PERMIT

SEWAGE DISPOSAL SYSTEM

HOWARD COUNTY HEALTH DEPARTMENT

SUBDIVISION Brookwood Farms LOT 10 ROAD 8134 Brookwood Farm Road

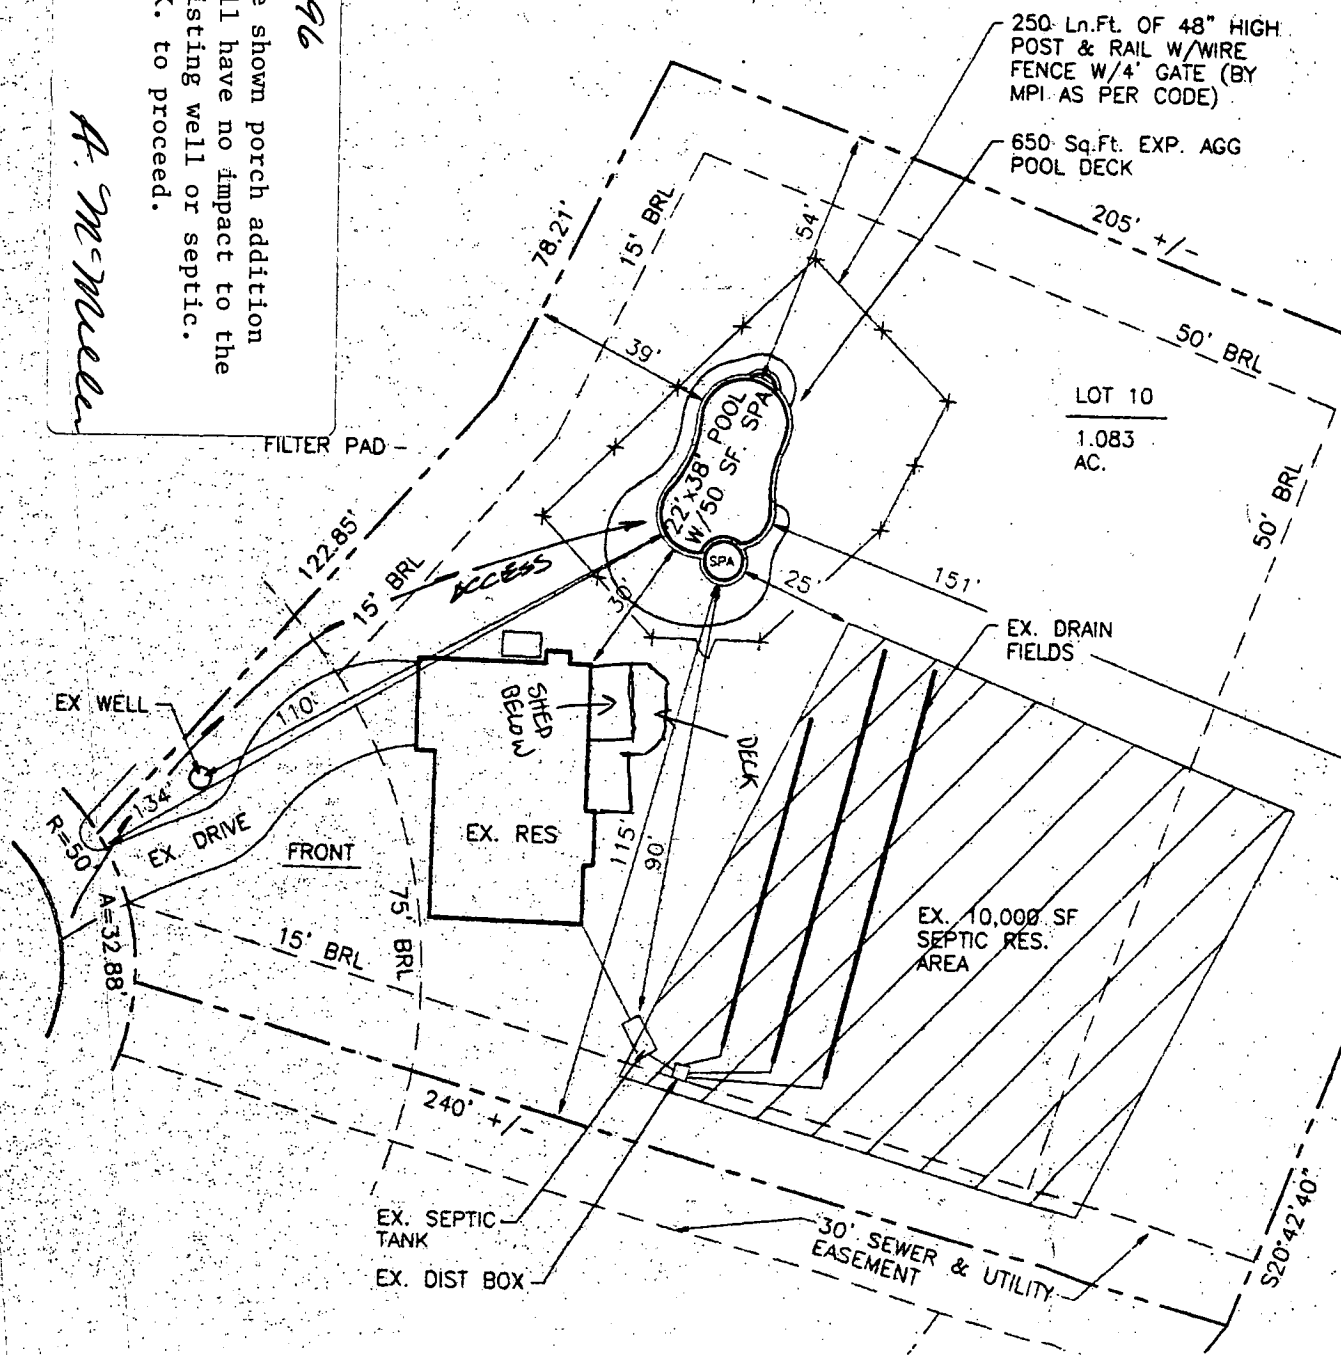
The shown porch addition will have no impact to the existing well or septic. O.K. to proceed.

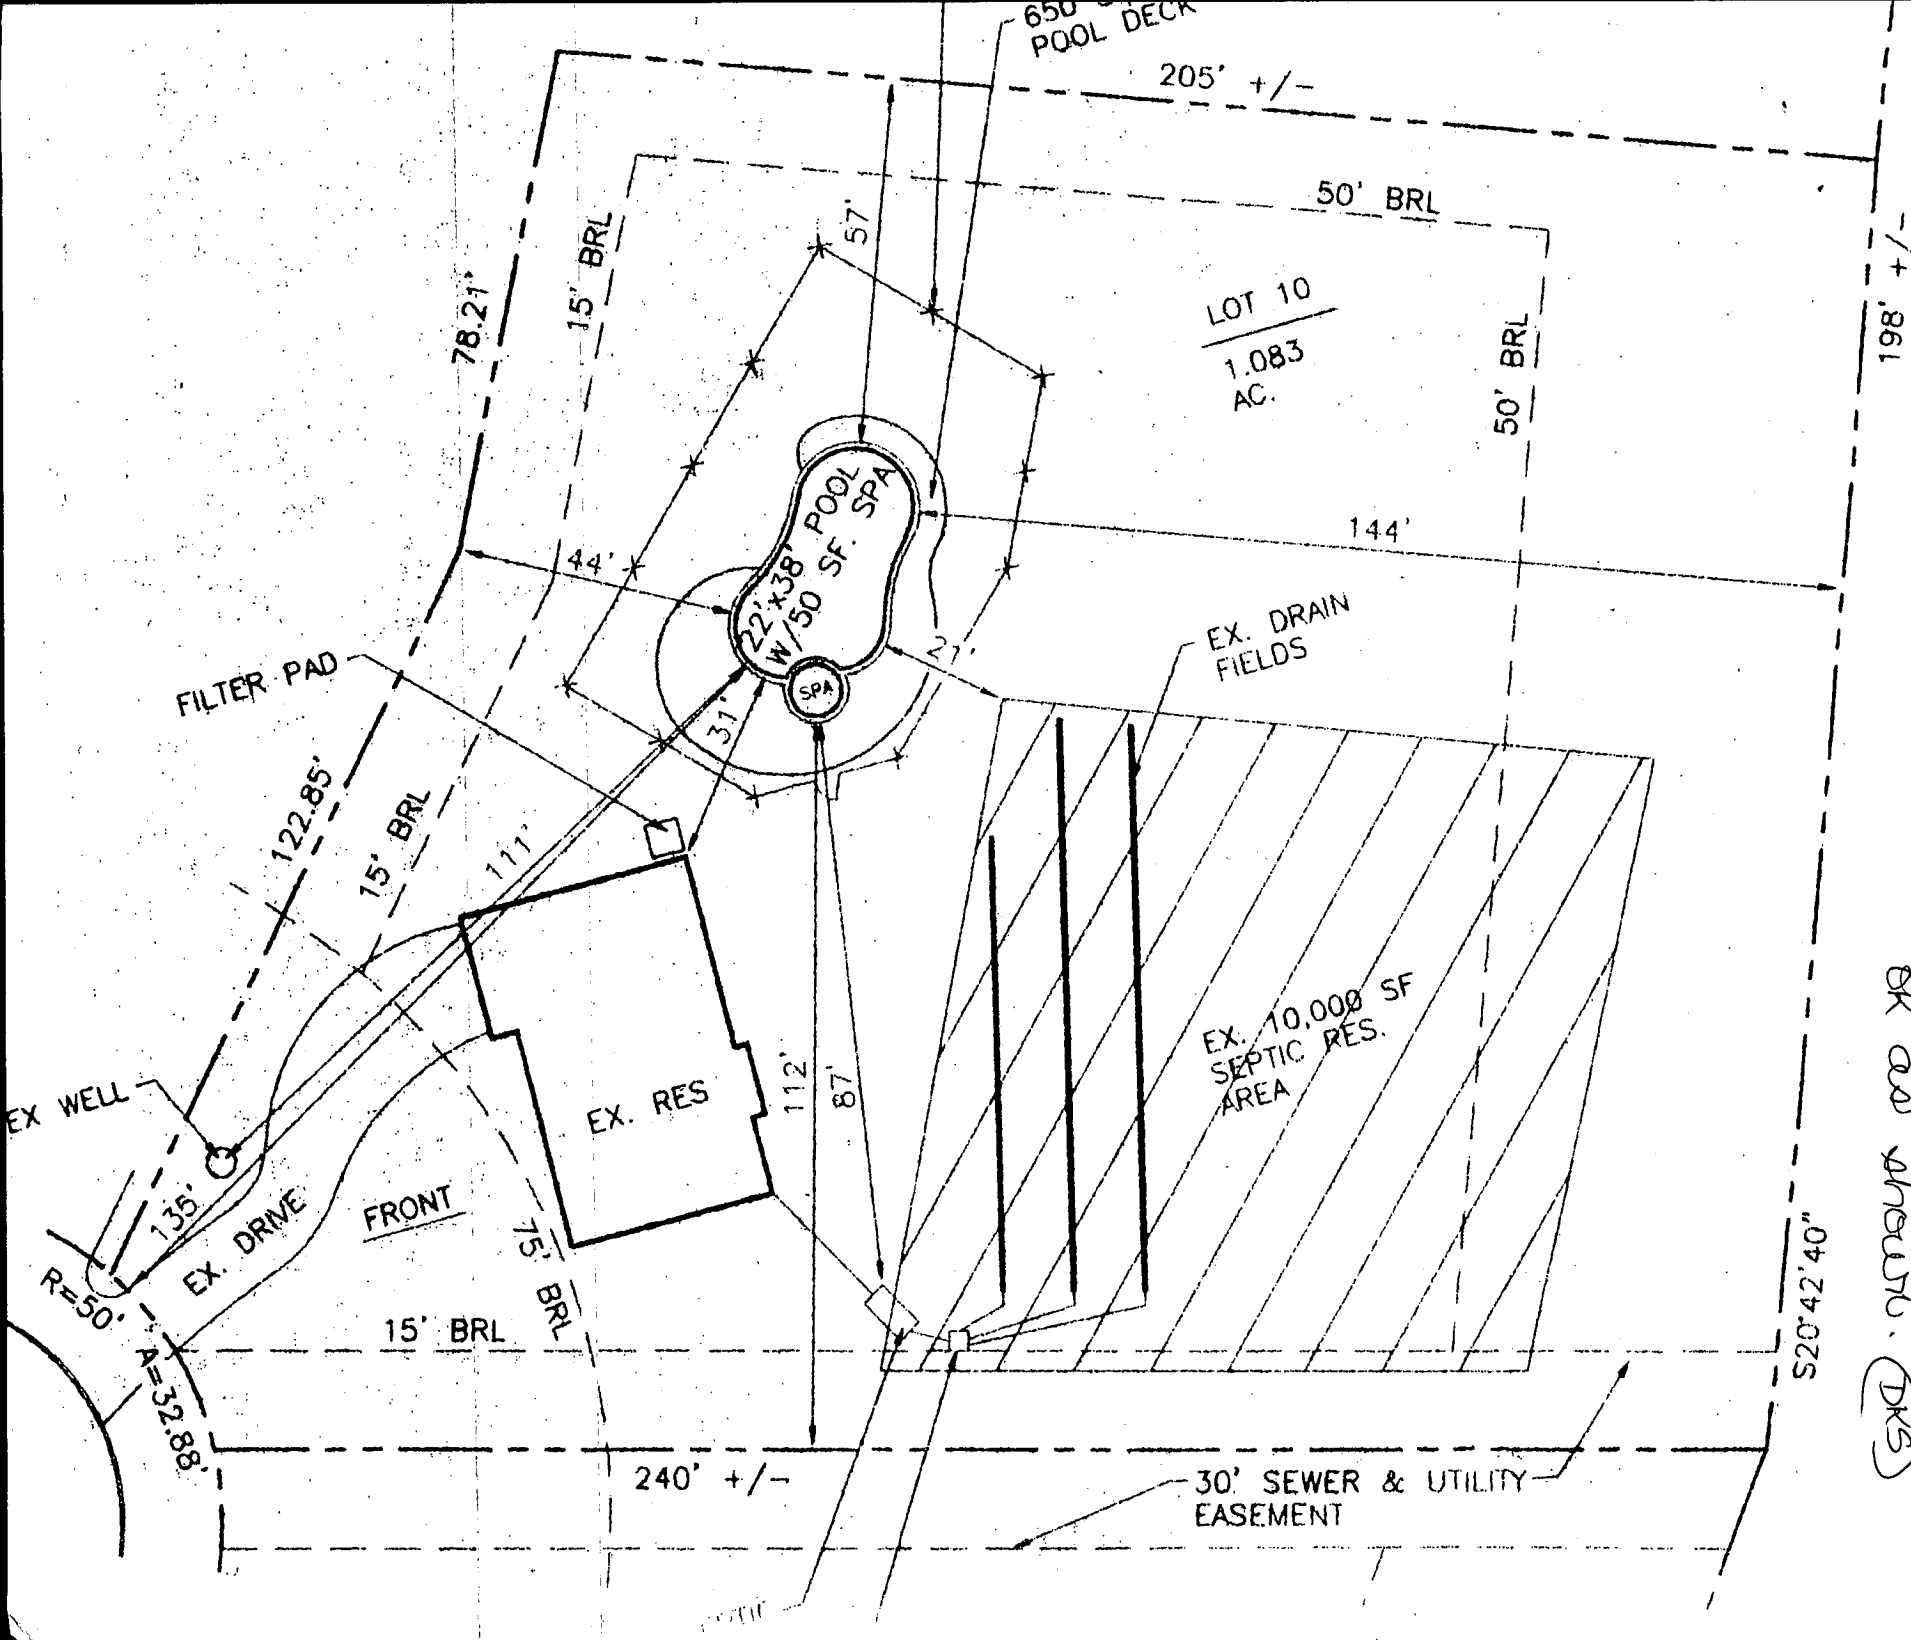
10/2/96 Proposed pool location
 BK and sheets. (DKS)
